## **Bike North Submission**

## **NSW Department of Planning and Infrastructure**

## **Exhibition of North West Rail Link Environmental Impact Statement 2**

*Recently Constructed Class 2 Bicycle Parking Compound at Eastwood Station*

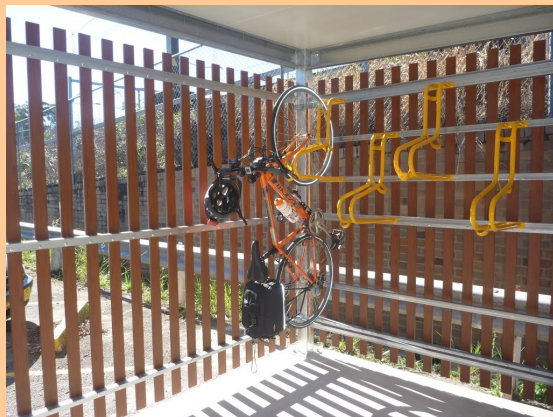
All 3 classes of parking must have roofing cover giving protection from wet weather

The proportions of the bicycle parking forms musty be considered. We suggest the following proportions may assist planning:

Class 1	Fully enclosed individual Lockers	15%
Class 2	Restricted access secure compounds	50%
Class 3	General access locking points (rails, bars etc)	35%
